**Re: Huntington Beach Energy Project (12-AFC-02)
Applicant's Responses to Staff's Workshop Queries and Related Air Quality
Modeling Files**

Huntington Beach Energy Project

(12-AFC-02)

Applicant's Responses CEC Staff's Workshop Queries (Air Quality)

FIGURE WSQ2-1
AERMOD Dispersion Modeling Setup for
Block 1 Operation and Construction of Block 2
 AES Huntington Beach Energy Project
 Huntington Beach, California

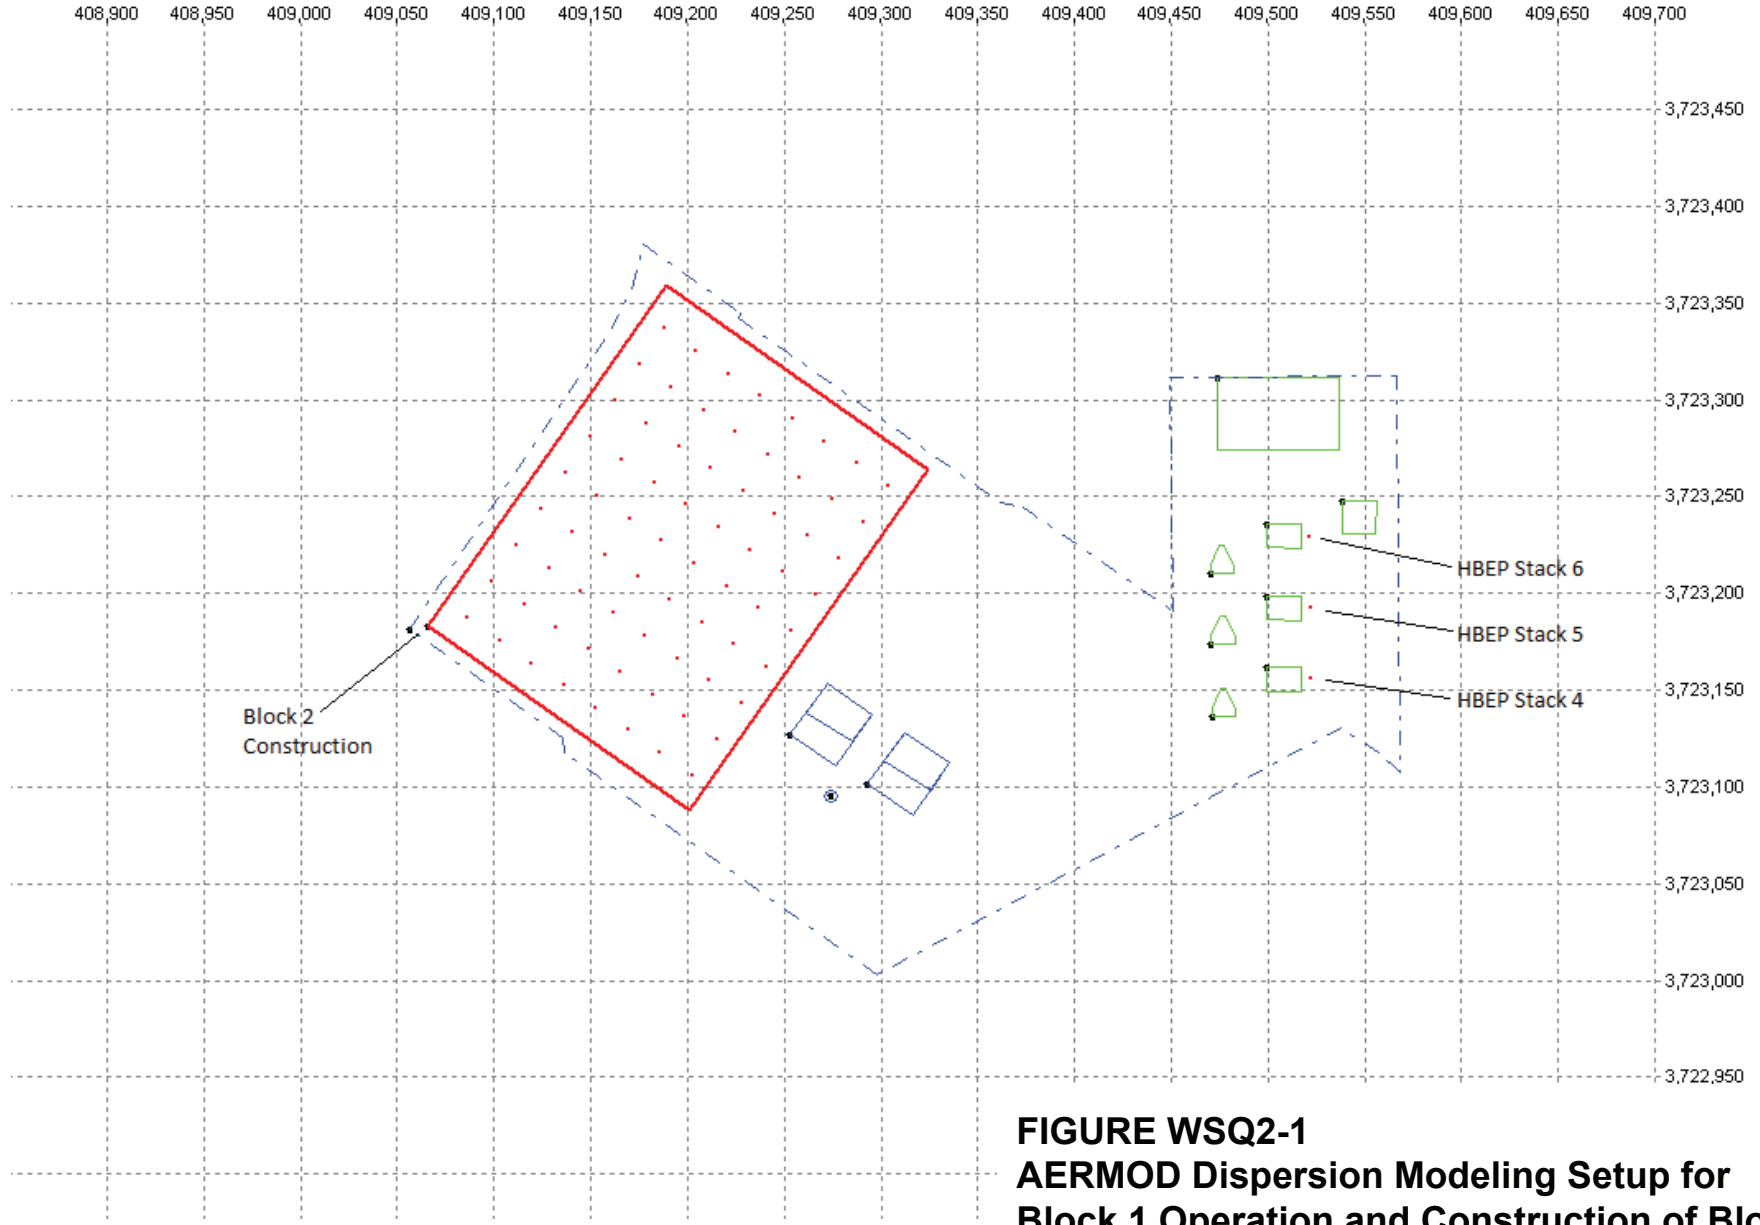
2. In conjunction with the revised construction impact analysis requested in WSQ 1, please prepare an impact analysis for all modeling pollutants for the following scenarios: 1) Block 1 operation plus Block 2 construction; 2) Block 1 and Block 2 operation plus demolition of Units 1 and 2; and 3) demolition of Units 3 and 4 as they align with the development of HBEP.

This scenario is intended to determine modeled impacts from the simultaneous operation of Block 1 and construction of Block 2. To evaluate the air quality impacts from this scenario, Block 1 operation emissions were obtained from AFC Table 5.1-24 (June 2012) and Block 2 construction emissions were obtained from Table 5.1A.46R from Appendix 5.1AR, which was submitted on February 22, 2013 as Attachment DR75-1 to Data Responses, Set 2A. Modeling was performed according to methodology presented in AFC Section 5.1.6.3, Air Quality Impact Analysis, with the following exceptions: construction emissions were modeled according to the methodology described in the response to Workshop Query 1 and the extent of the receptor grid was reduced to 10 kilometers (km) from the project fenceline. The AERMOD modeling setup for this scenario is presented in Figure WSQ2-1.
